**Project:**  
BMO University Plaza

**Submittal Review No.:**  
SX-025

**Submittal Review Title:**  
HVAC Split AC Unit

| SHOP DRAWING NAME:     | SPLIT AC Unit                          |

# DIMENSIONS: PUY-A18NKA7

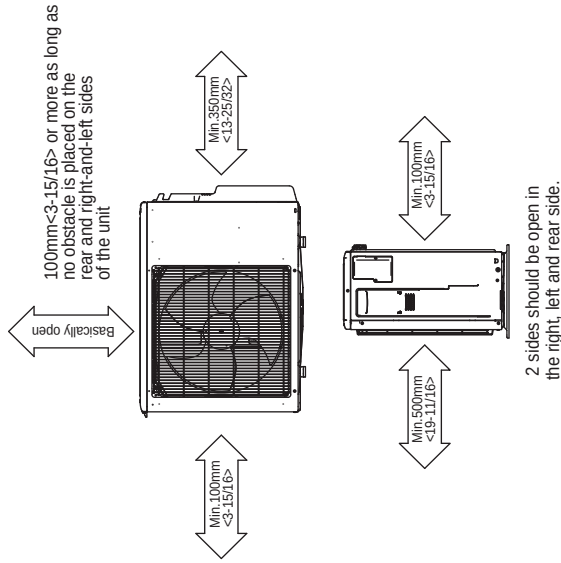
**MIT: OUTDOOR UNIT SHOULD BE INSTALLED ABOVE THE SNOW LEVEL**
